# Answer

Re: FCC ID PB7GN9015

Applicant: GN Netcom A/S

Correspondence Reference Number: 17585

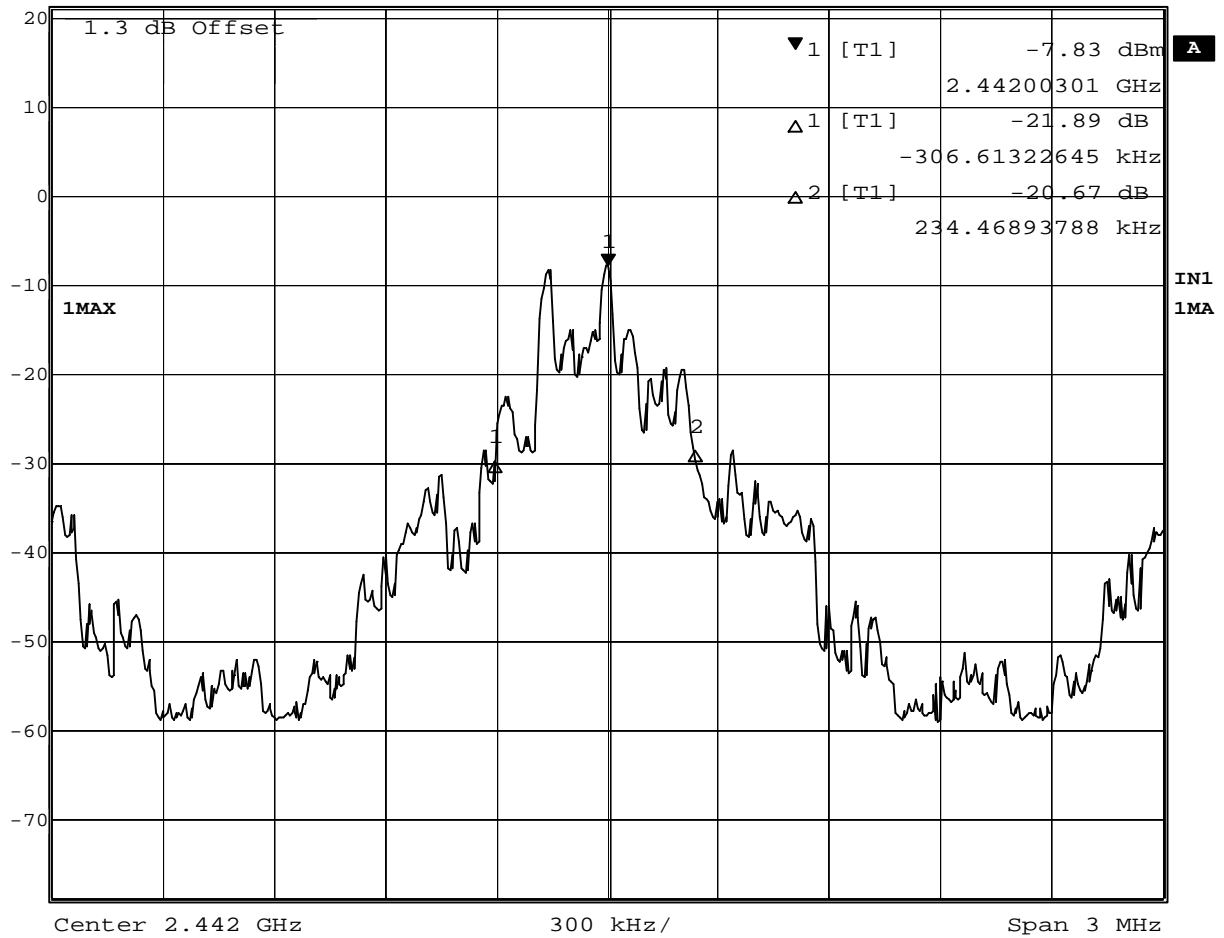
10) g) 20 dB bandwidth plot.

**Plot of 20 dB bandwidth in paging mode = 640 kHz.  
The markers on the screen are not set correctly so the bandwidth of about 640 kHz  
is manually read from the screenshot.**
